HORT SCHOOL MODERNIZATION

BAKERSFIELD CITY SCHOOL DISTRICT

FLOOR PLAN

A 2.02

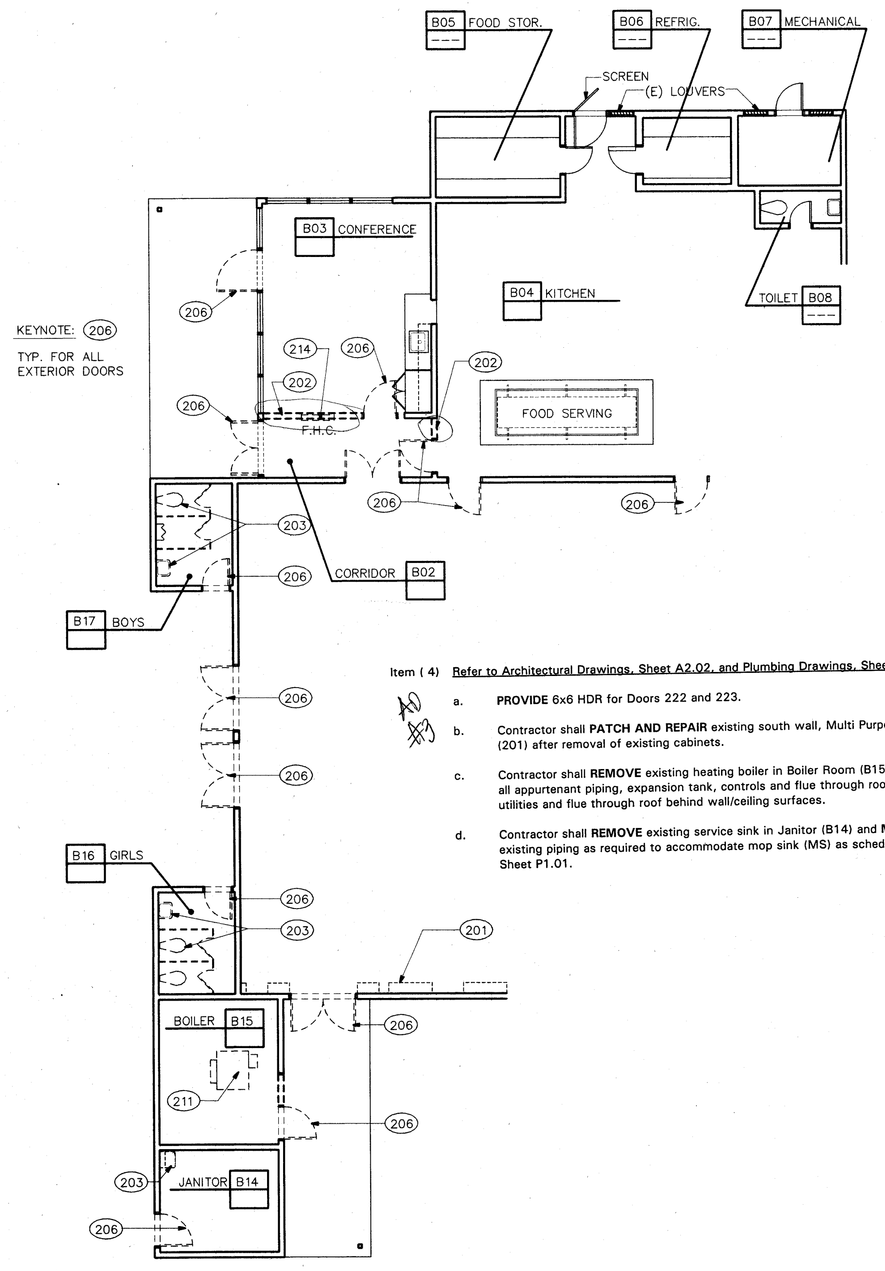
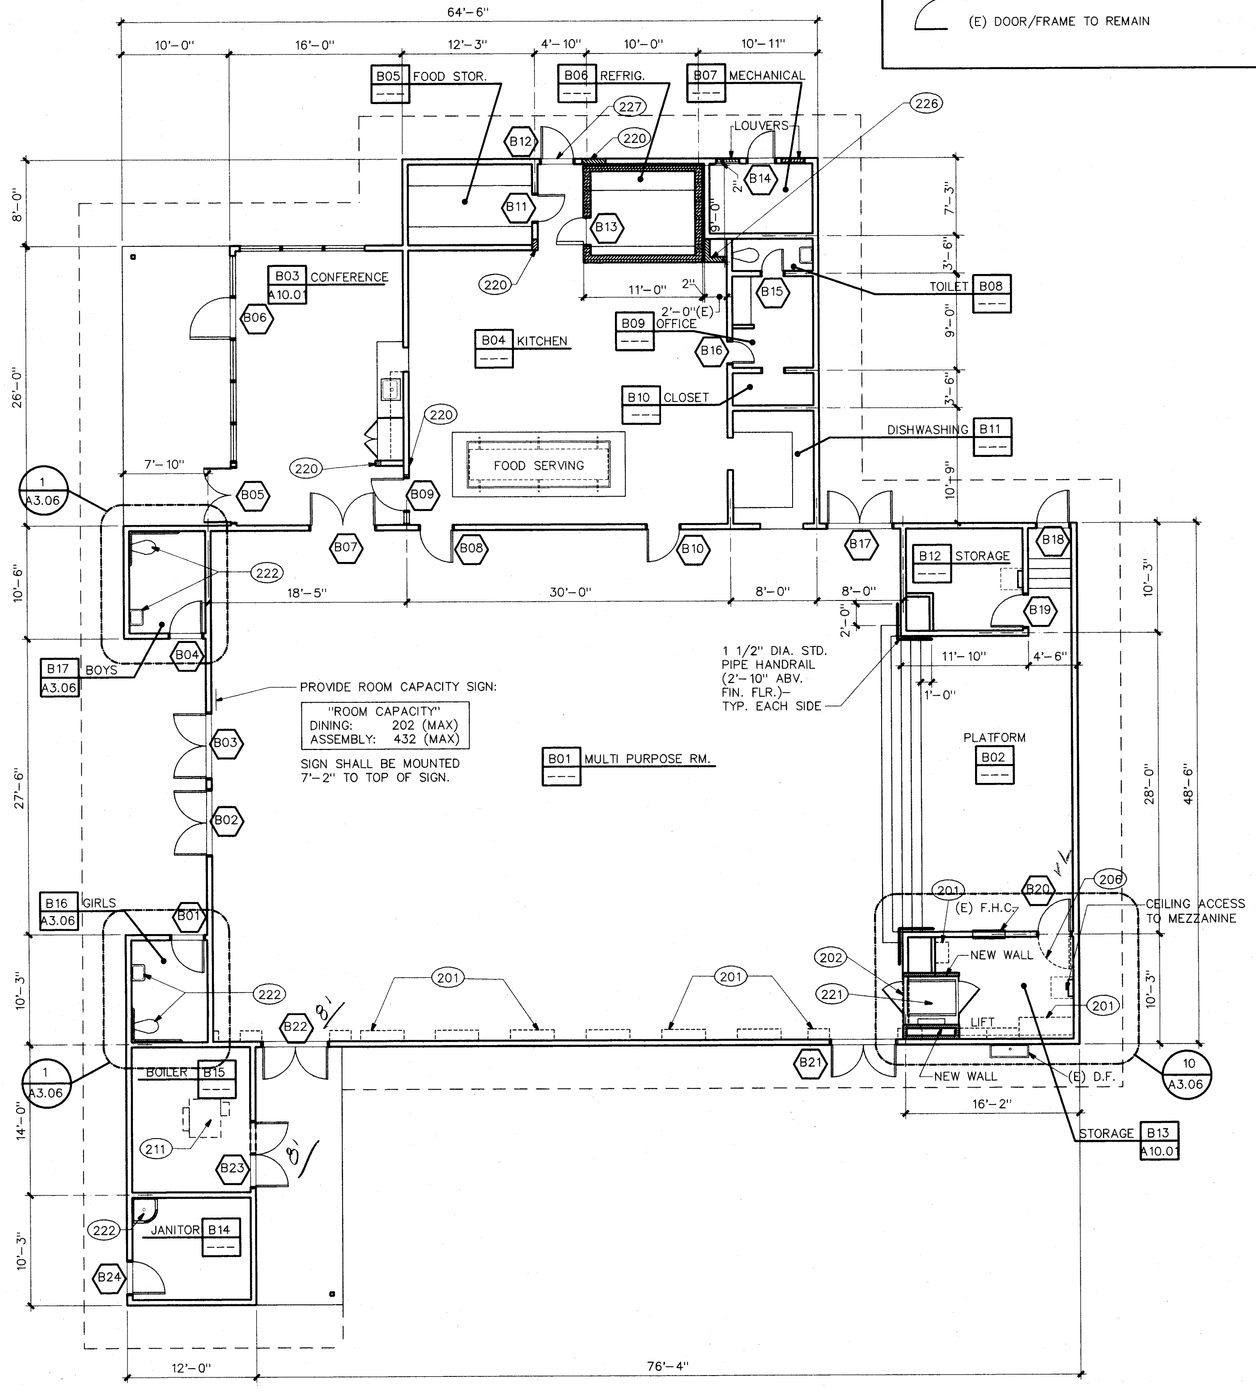
Item (4) Refer to Architectural Drawings, Sheet A2.02, and Plumbing Drawings, Sheet P2.01:

a. **PROVIDE** 6x6 HDR for Doors 222 and 223.

b. Contractor shall **PATCH AND REPAIR** existing south wall, Multi Purpose Room (201) after removal of existing cabinets.

c. Contractor shall **REMOVE** existing heating boiler in Boiler Room (B15), including all appurtenant piping, expansion tank, controls and flue through roof. Cap all utilities and flue through roof behind wall/ceiling surfaces.

d. Contractor shall **REMOVE** existing service sink in Janitor (B14) and **MODIFY** existing piping as required to accommodate mop sink (MS) as scheduled on Sheet P1.01.

PARTIAL FLOOR PLAN
BUILDING B

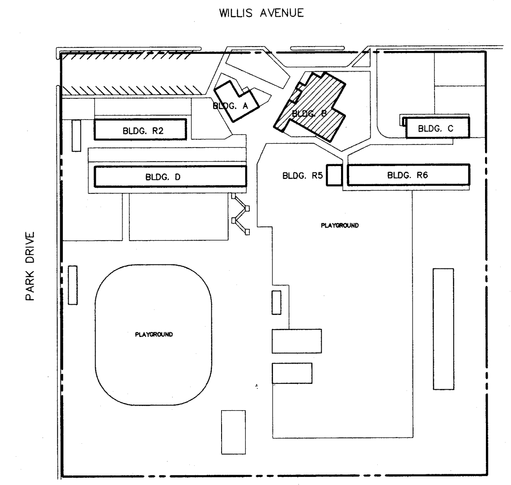
Item (10) Refer to Specification Section 14420 "Wheelchair Lifts", and Architectural Drawings, Sheets A2.02 and A3.06:

Contractor shall provide full-size door (3'-0" x 6'-8") with appropriate accessible door hardware on west side (lower level) of platform lift and manufacturer's standard lift gate on east side (upper level) of platform lift as an integral part of the platform lift.

Item (9) Refer to Architectural Drawings, Sheet A2.02, specifically Storage Room, B13:

a. Contractor shall **REMOVE** existing floor of Storage Room B13 as required to install platform lift. **PATCH AND REPAIR** existing floor material as required.

b. Walls on north and south side of platform lift to extend full height, floor to ceiling above. **PROVIDE** short wall (2x4 with gypsum board one side) at east side of platform from concrete floor to subfloor.
